Lands at Kilbride, Arklow

Quality Audit

Certain Assets of Dawnhill & Windhill Ltd.

May 2025

Figure 3.1 – Gap in Provision Between Existing Footpath Termination & New Footpath Facility

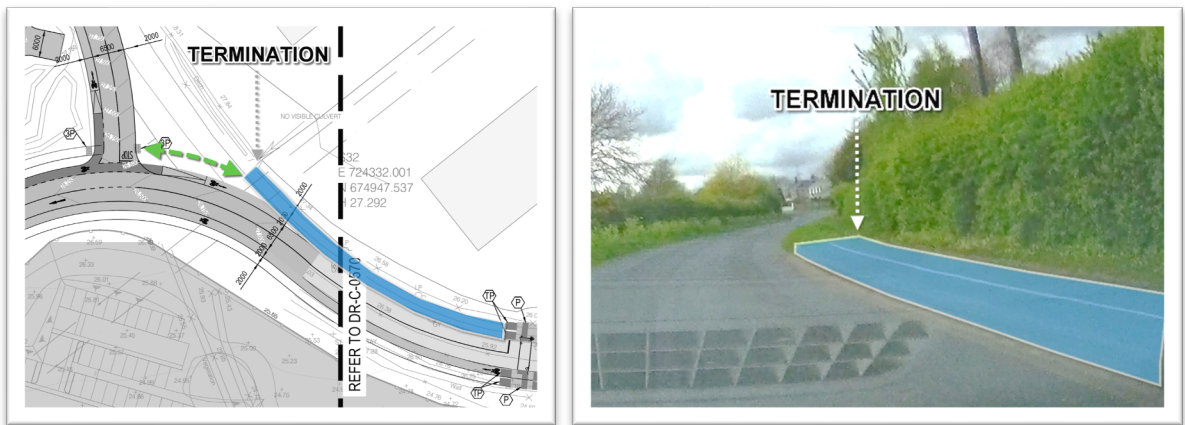
3.1 Problem: Continuity At Termination of Footpath & Cycle Track

Location: Section of Re-Aligned Local Road (Sheet 2 of 7)

Failing to provide a seamless connection for pedestrians here could lead to slips, trips and progression issues for mobility impaired road users.

A seamless footpath connection should be provided here.

2.1	Y	Y	Comment: continuation of path provided and incorporated on site layout drawing 2432-DOB-XX-SI-DR-C-0520	Comment noted.
2.2	y	N	The staggered junction main through road is southeast to northwest. The 2 arms forming the junction serves 6 dwellings to the southwest and 11 to the north east. Both these arms have 2 options for exiting on the main arterial roads through the site, so up to 3 houses may use this junction to the south west and 5 or 6 to the northeast. There is no demand for traffic from the north to turn onto both these streets and it is likely that all traffic using this junction will be approaching from the southern direction only. Given the very low volumes of traffic and that all of the traffic turning movements will be from the southern arm only, we would consider that the staggered junction will not create a traffic hazard in its current arrangement	Yes.

Figure 3.2 – Partial 'Left to Right' Side Road Stagger Creating Opposition Between Right Turners

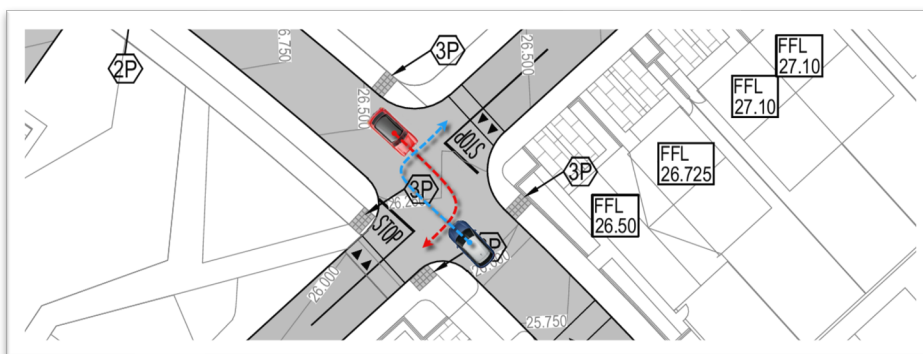
3.2 Problem: Opposing Right Turn Conflicts

Location: Opposing Streets with Partial Stagger (Sheet 2 of 7)

The unusual 'left to right' side road stagger is likely to result in head-on type conflicts between opposing vehicles both wishing to turn right at the same time.

The offset between the stagger should be either i) removed, to create a standard cross roads, ii) reversed to create a 'right to left' stagger or iii) increased to allow opposing right turners sufficient space to hook around each other.

Figure 3.4 – Left Turners Over-Running Hatch & Long Crossing Distance for Pedestrians

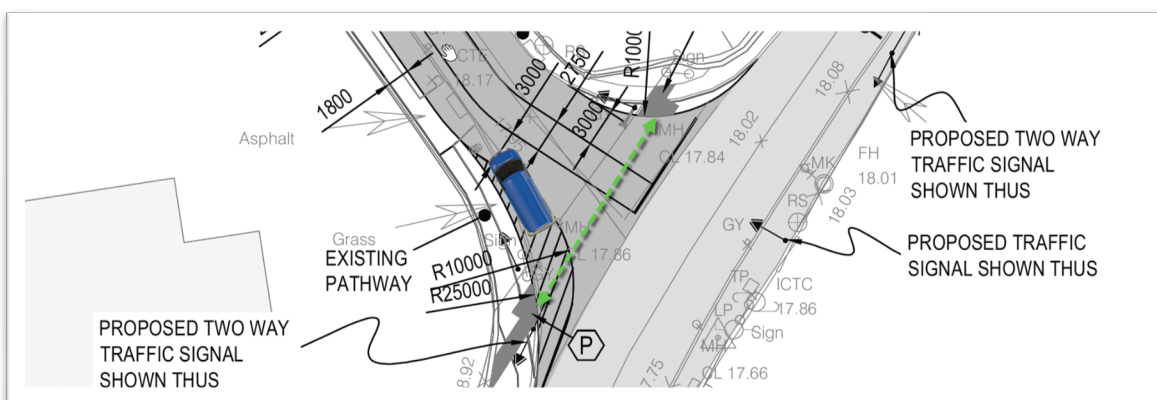
3.4 Problem: Long Crossing Distance for Pedestrians

Location: Beech Road / Dublin Road Junction Improvement (Sheet 7 of 7)

The hatched island will require pedestrians to make an uncomfortably long street crossing. Inbound left-turning drivers may overrun the hatch, increasing both vehicle speeds and the risk of conflict with pedestrian.

The suggested hatched road marking left turn build out should be substituted with a standard kerbed island build-out.

2.4	Y	N	It is accepted that the hatched island requires a longer pedestrian crossing that normal. However, the left hand turning of HGV vehicles at this junction requires this area to be level with the road to avoid HGV mounting the kerb. Refer to Autotrack drawing 2432-DOB-XX-SI-DR-C-0610. We would suggest that the provision of the hatching is necessary for pedestrian safety at this junction, as the normal and standard build out of a kerb island is not feasible in this instance.	Yes - also noting that the traffic signal controlled crossing will offer mitigation.

Figure 3.5 – Example Entry Points to Homeszones Where Pedestrians & Vehicles will Share Space

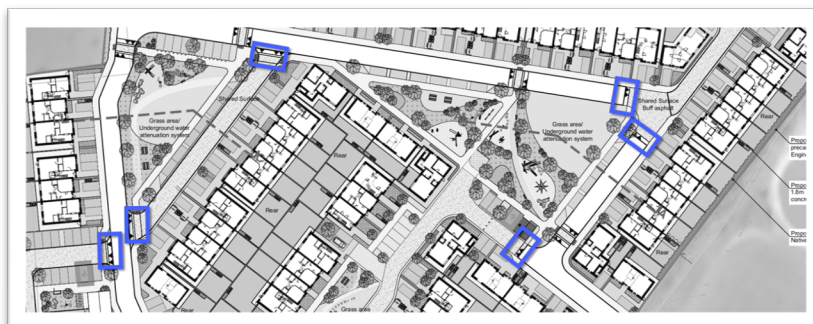
3.5 Problem: Treatment of Homeszone Entry Points

Location: All Homeszone Gateway Entry Points

Drivers may not immediately recognise that on Homeszone streets, they are required to yield to pedestrians, including children playing, who share the road space. This situation has the potential to heighten the risk of conflict between vehicles and vulnerable road users within Homeszone streets.

Drivers should be clearly informed that they are entering a Homeszone street. Measures might include conscious pedestrian refuge zones, surface colour changes, in-lane roundels, and gateway signage at entry points.

Problem Reference (Section 2)	Designer Response Section			Audit Team Response Section
	Problem Accepted (yes / no)	Recommended Measure Accepted (yes / no)	Alternative Measures or Comments	Alternative Measures Accepted (yes / no)
2.5	Y	Y	Surface colour changes and gateway signage will be provided at the entry points to home zones as recommended.	Comment noted.
